Portishead Branch Line (MetroWest Phase 1)

TR040011

9.10 ExA.WQ1.D2.V1 – Applicant's responses to the Examining Authority's Written Questions ExQ1

Applicant's Responses to the Examining Authority's EXQ1 Round of Written Questions

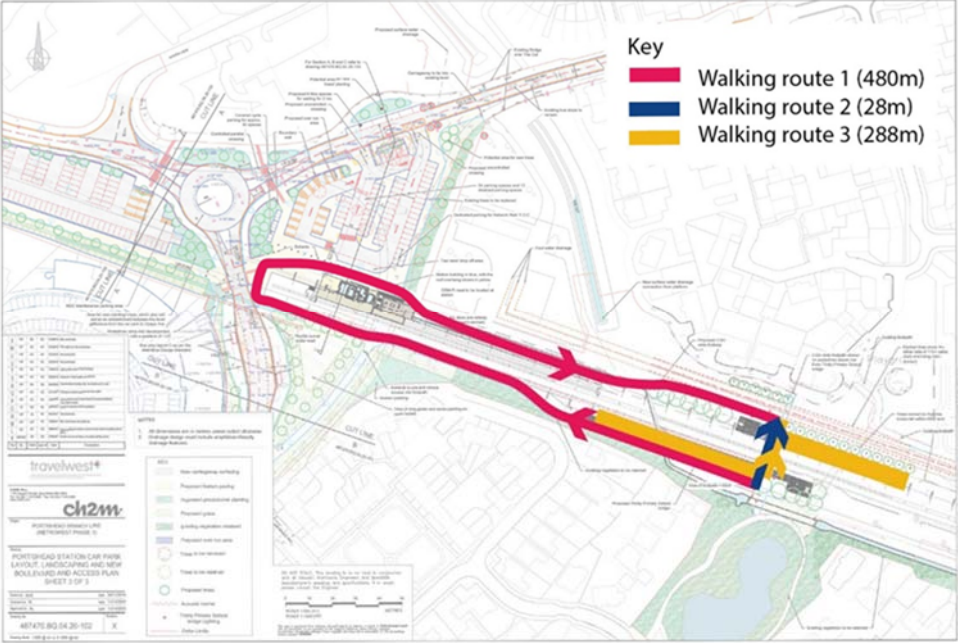
ExQ1 No.	Type / Category	The Question	Current response
			<p>The overall design seeks integration with other modes of transport with priority given to walking, cycling, bus and taxi, connections to the town centre via the proposed boulevard, boundary treatments and landscaping.</p> <p>DAS Section 17: Figures 17 – 20 illustrate the existing site context and the contemporary nature of the adjacent buildings and urban landscape. The contemporary nature of the adjacent buildings and context has been used to inform the choice of proposed materials for the external appearance and elevations.</p> <p>The proposed materials are set out in the Legend/Notes on drawing Portishead Station Building Design: Proposed Station Buildings (APP-018; DCO Document Reference 2.11) and include through colour render, metal roofing system, natural stone for boundaries and plinths, and colour coated metal.</p> <p>DAS Figure 26 (page 37) illustrates the proposed highway alteration, parking and station layout with the main elements identified within the key, and along with DAS Figure 31 (page 31) illustrates how the buffer enclosure and the station building in particular sit within the overall context.</p> <p>The buffer stop enclosure is enclosed by a lightweight cladding system with natural stone detailing. The proposed materials are shown on drawing Portishead Station Building Design: Proposed Station Buildings (APP-018; DCO Document Reference 2.11). A light weight cladding system is proposed to limit the need for extensive piled foundations which would be required for heavy brick, block or stone walls. The solid cladding system screens views to the buffer stop area which would otherwise be through a palisade fence.</p> <p>The station is a gateway as a result of its position in the urban context and is a feature in the view from the adjacent road network and pedestrian routes.</p> <p>It is not the intention to provide more detailed designs of the external appearance of the station building and associated structures during the course of the Examination period because the scheme detailed design (GRIP 5) has not yet been completed and is not programmed to be completed until after the DCO</p>

ExQ1 No.	Type / Category	The Question	Current response
			<p>examination closes. Whilst it is not anticipated the detailed design will result in any material changes to the design of Portishead Station, some minor but important changes may be required at detailed design, or in consultation with the relevant planning authority.</p>
DE.1.2	<p>Work No 7 Trinity Footbridge - Design Q to The Applicant</p>	<p>Plans 2.15-2.17 [APP-019] include general arrangement plans of the proposed footbridge at Tansy Lane ('Trinity Bridge'). The Design and Access Statement [APP-196] figures 31-33 provides indicative visuals of Portishead railway station but not the bridge. Provide:</p> <p>Indicative visuals of the type of footbridge proposed. A more detailed explanation of the design and locational criteria for the proposed footbridge having particular regard to the surrounding residential development and school building.</p> <p>Details of colour/paint finish of the footbridge, or how this will be determined at a later stage.</p> <p>Any mitigation proposed to reduce the visual impact of the bridge.</p> <p>You may wish to combine the answer to this question with questions DE1.3 and NV.1.3.</p>	<p>Indicative visuals of the proposed Trinity Bridge are provided in the Environmental Statement, Volume 4, Appendix 11.4 Photomontages Technical Report (APP-152; DCO Document Reference 6.25).</p> <p>On the issue of design and location criteria reference should be made to the following documents:</p> <ul style="list-style-type: none"> • Trinity Footbridge Plans (APP-019; DCO Document Reference 2.15 to 2.17); and • Portishead Station Car Park Layout, Landscaping and New Boulevard and Access Plan (APP-035; DCO Document Reference 2.38). <p>Trinity Bridge is located close to the existing crossing point over the disused railway and is being provided to mitigate severance of a well-used crossing.</p> <p>Both steps and ramps are provided to the bridge. The overall length of the ramps has been reduced as much as possible and they utilise a 1:15 slope with intermediate horizontal landings which are located at the supporting columns.</p> <p>The location of the bridge, in addition to providing a means of crossing the railway close to the location of the existing at grade crossing, has to be where there is sufficient space to achieve a feasible design, accommodating ramps and conforming to the various design standards.</p> <p>As explained further in our response to ExA question DE.1.3, the only location where there is sufficient space that meets these criteria is the location the Applicant is proposing.</p> <p>Figure DE.1.2 – 1</p>
